Subject: Submission for DA2020/0302

Attached is a letter and some supporting documents in relation to DA2020/0302, at 41 Upper Clifford Avenue, Fairlight. Can you please add this to the submissions for the DA.

PROJECT DETAILS
DUAL OCCUPANCY WITH BASEMENT CARPARKING
AND SINGLE DWELLING AT
41 UPPER CLIFFORD AVE
FAIRLIGHT NSW 2094

DRAWING TITLE
VIEW ANALYSIS
SHEET 01
SCALE STATUS
NTS DA

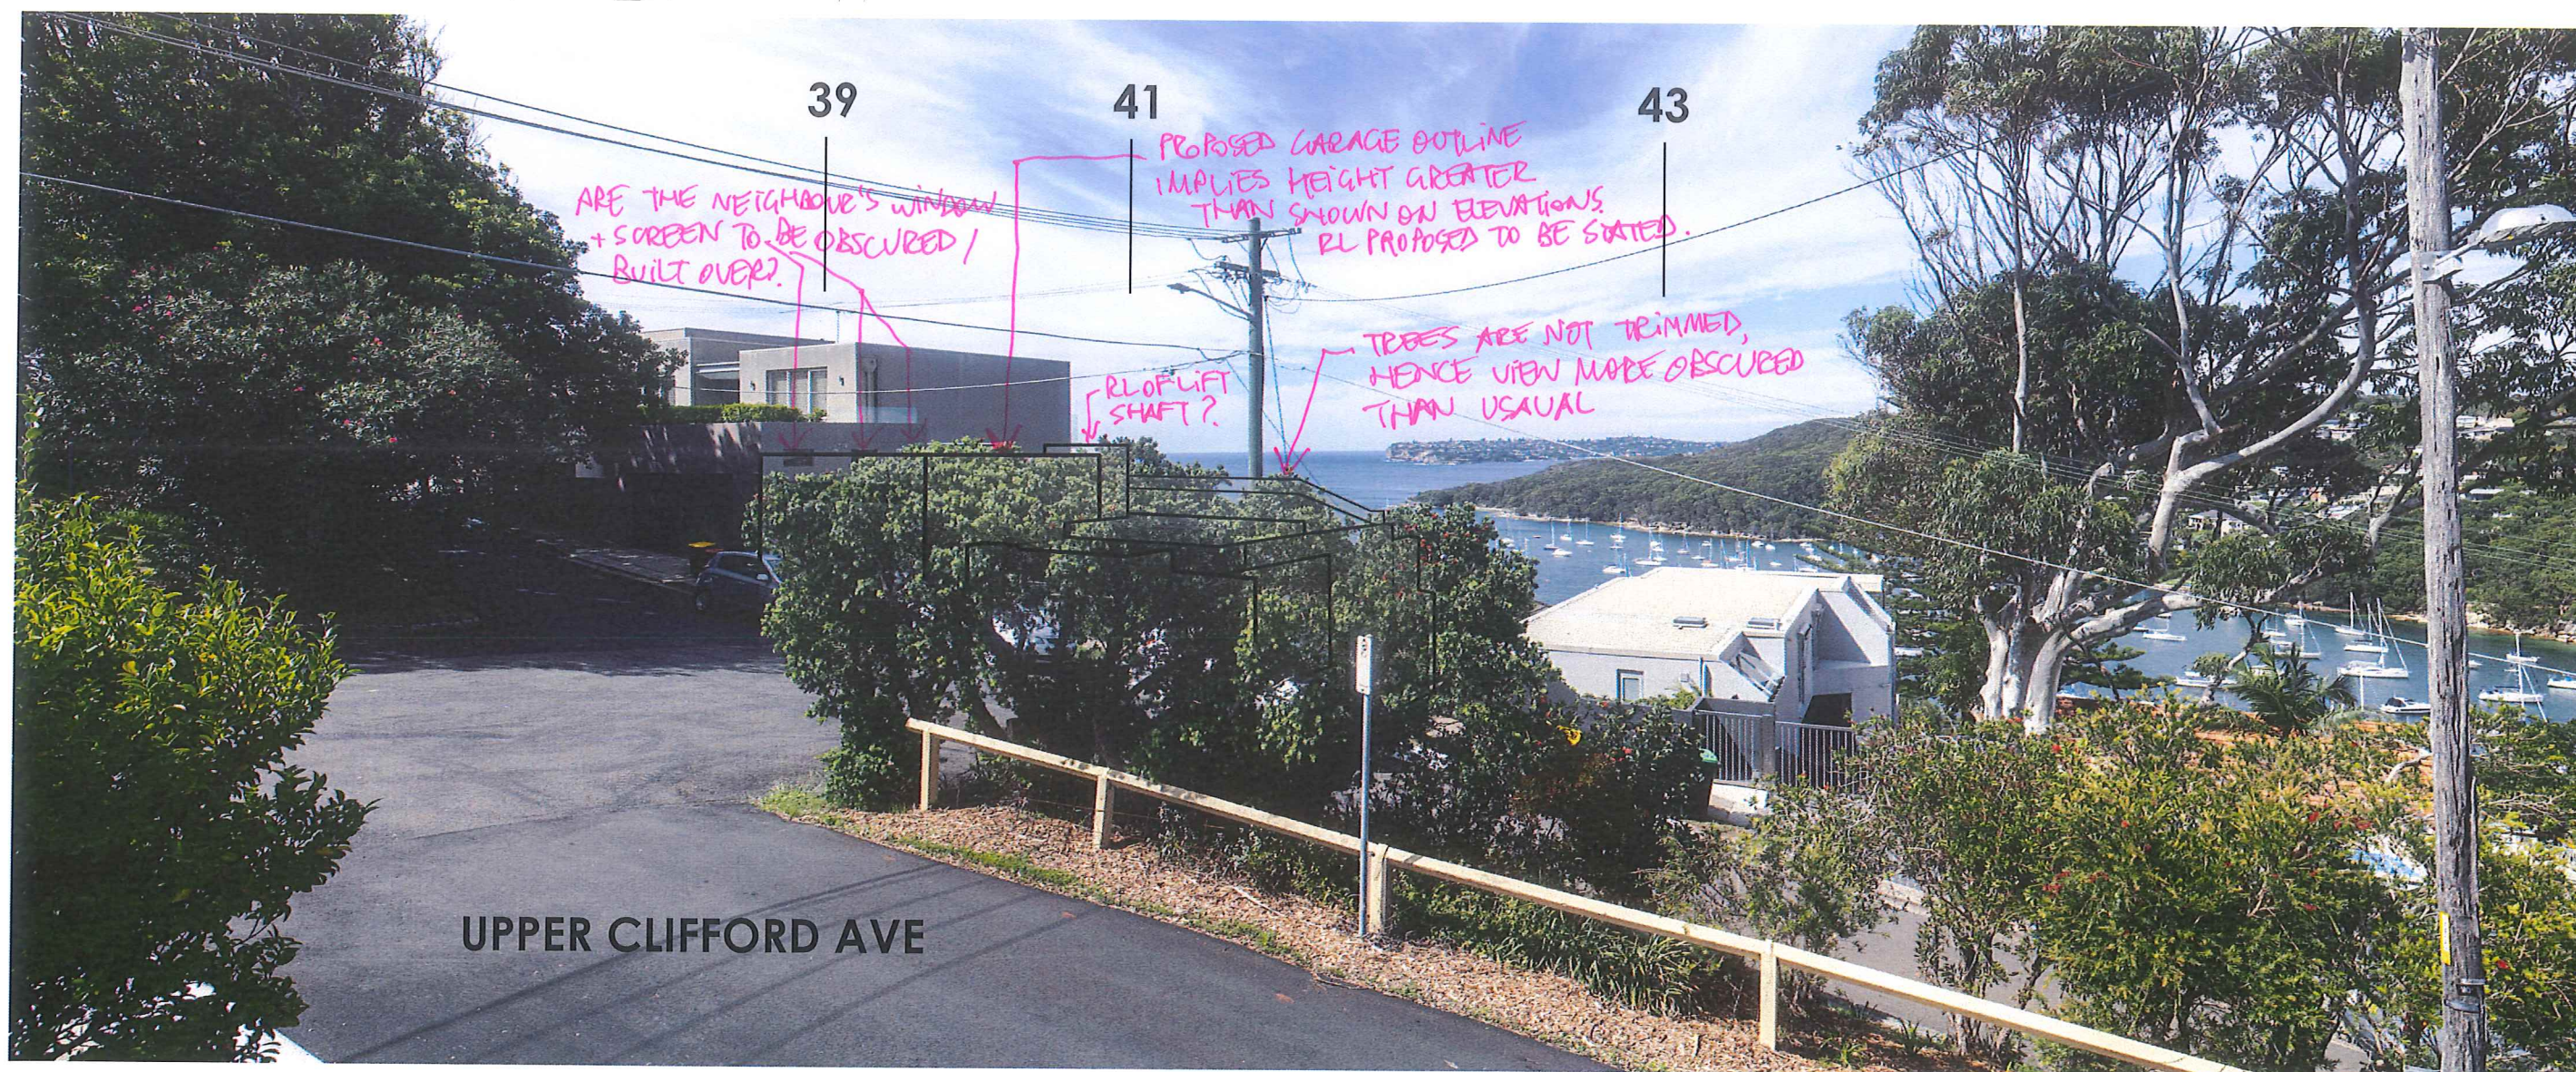
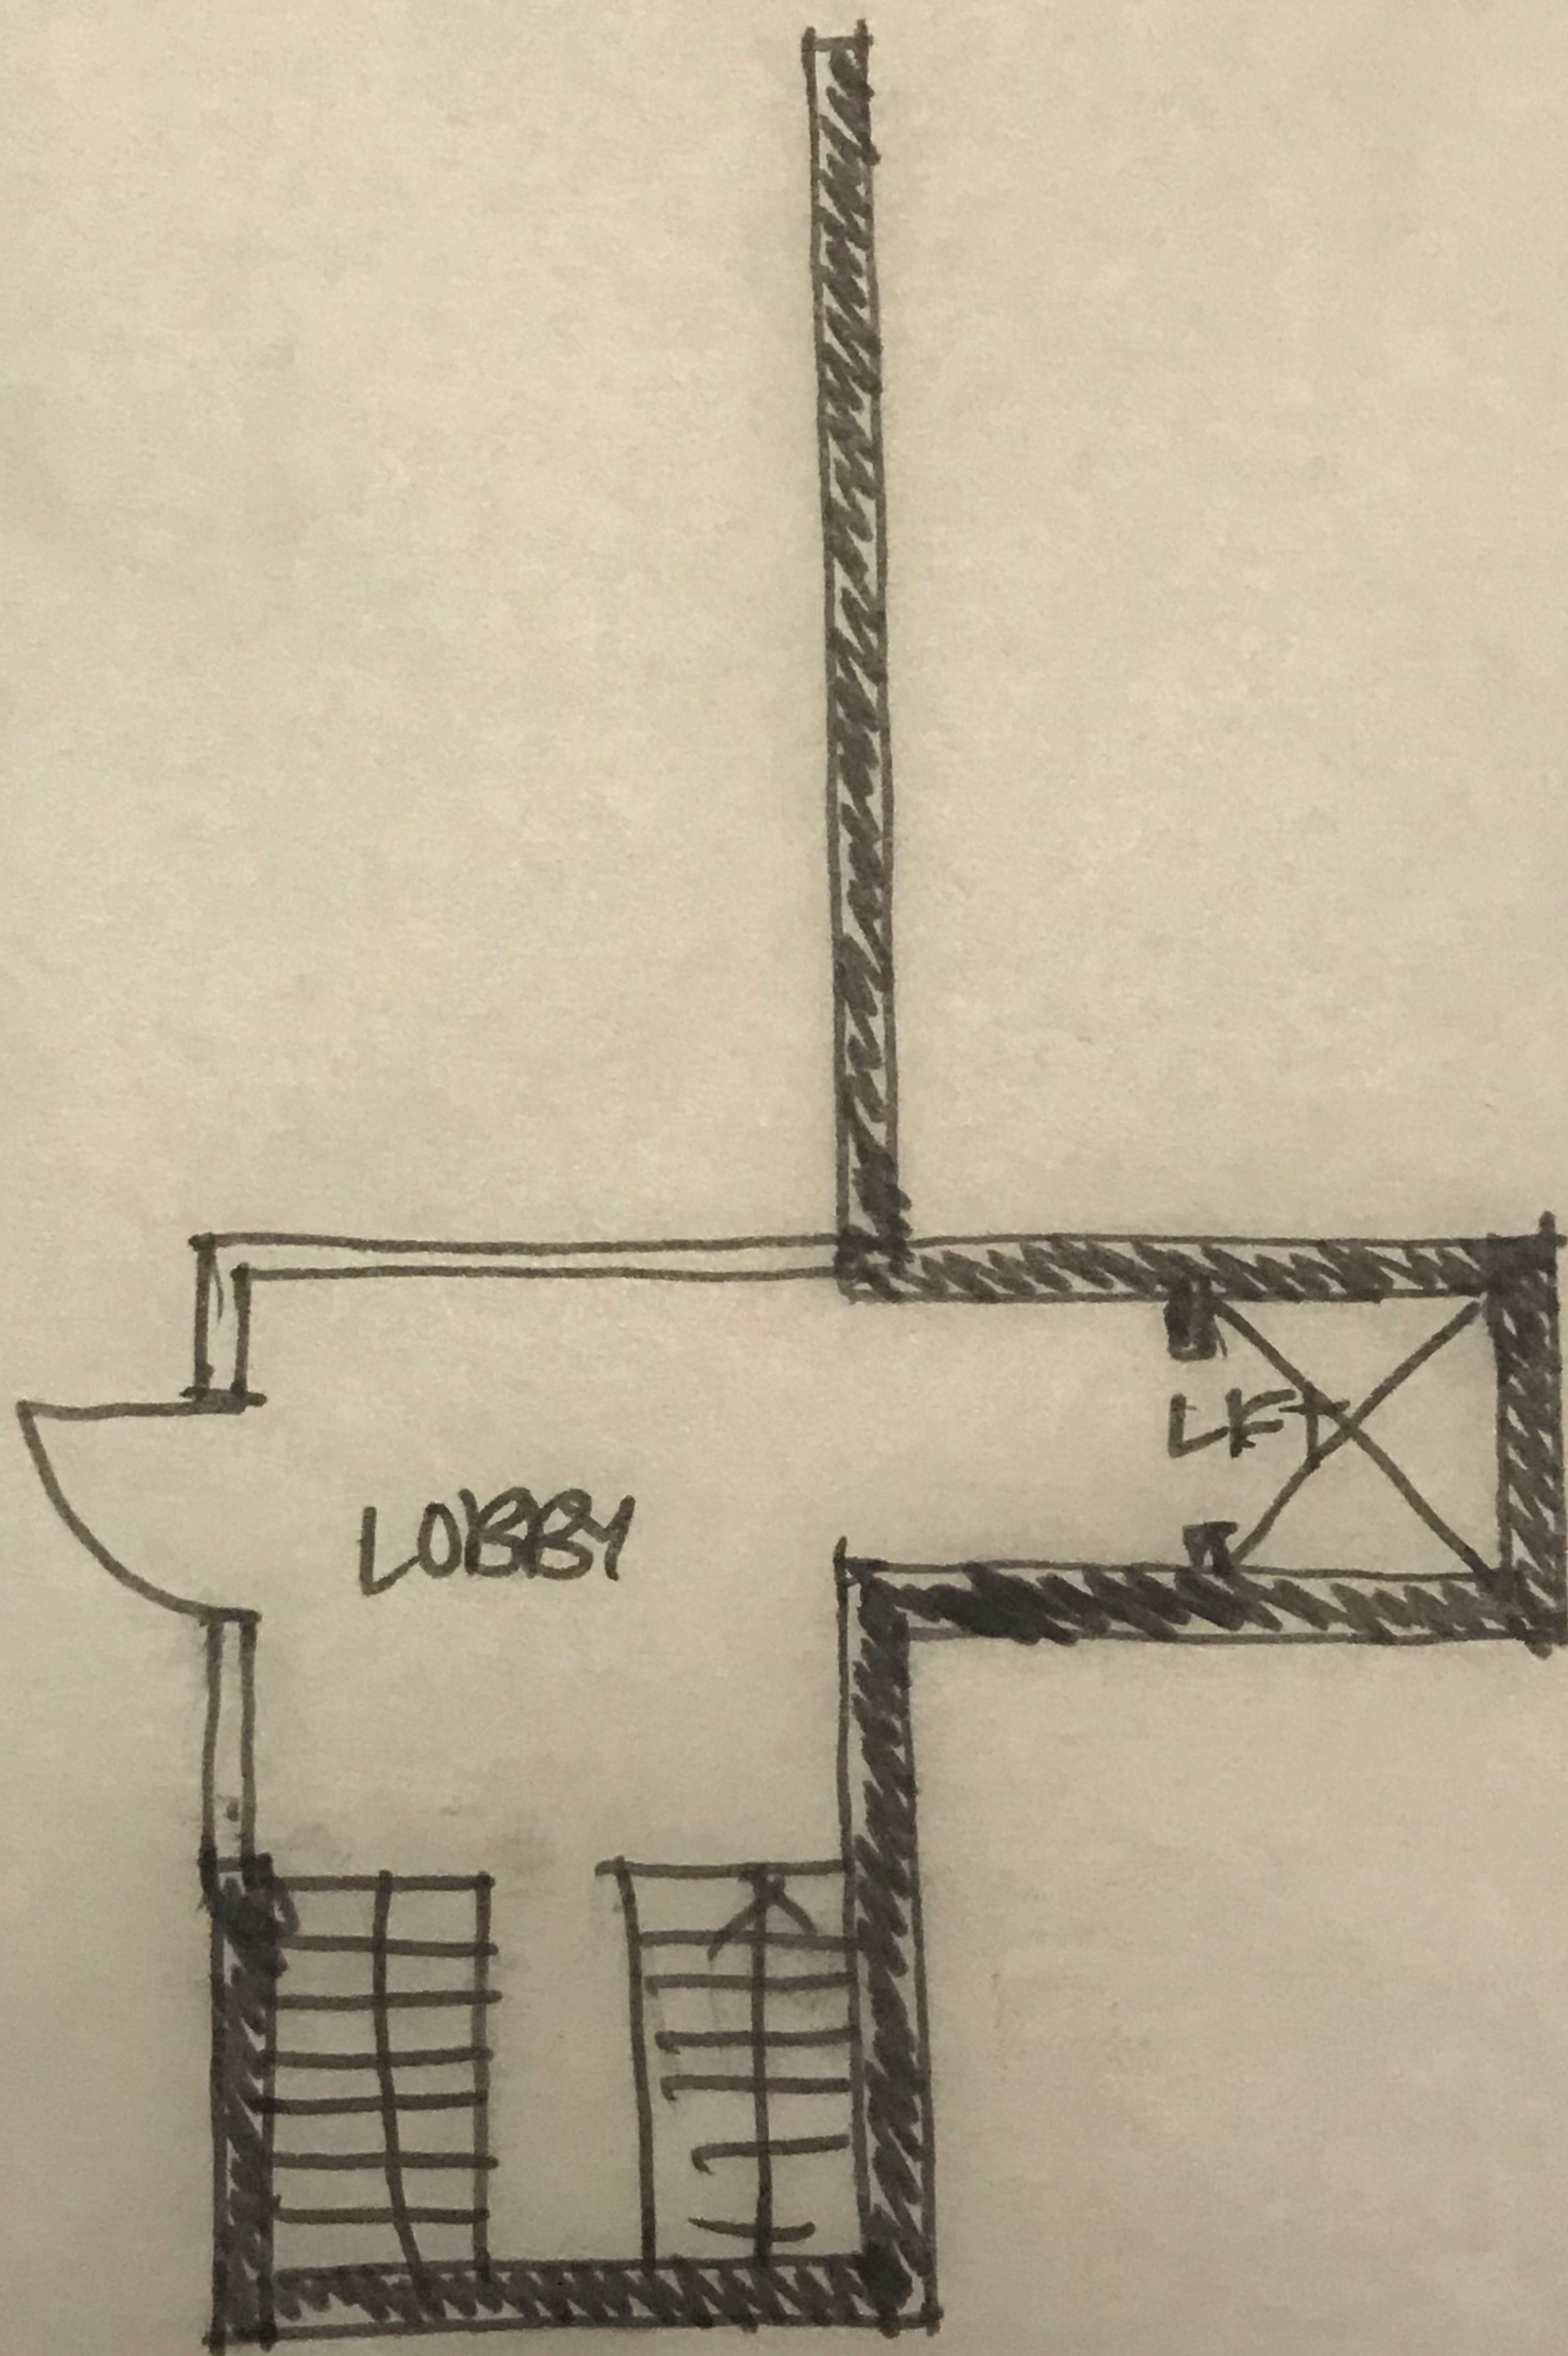
- i. The photo on View Analysis Sheet 01 in the Master Set of Plans is taken from the western edge of our property (and, it appears, from a low height on our terrace). This is misleading and significantly understates the view loss from our house.
- ii. The black outline in this photo implies that the roof of the new garage in Unit 1 will go up to the top of the windows in the garage at 39 UCA, with the roof of the living area in Unit 1 just below this. This would devastate the view from our house, taking over 80% of our ocean views across the Harbour to South Head.
- iii. Even if the new garage is only built to the height of the existing garage at 41 UCA, as implied on page 16 of the Master Set of Plans, this would still take over half of our ocean view to South Head (due to the move to a double garage and the living area of Unit 1).

PHOTO TAKEN FROM WESTERN EDGE,
AT BALUSTRADE, OF TERRACE.
THIS UNDERSTATES VIEW LOSS FROM
LIVING ROOM/BALCONY AT SITTING/STANDING HEIGHT
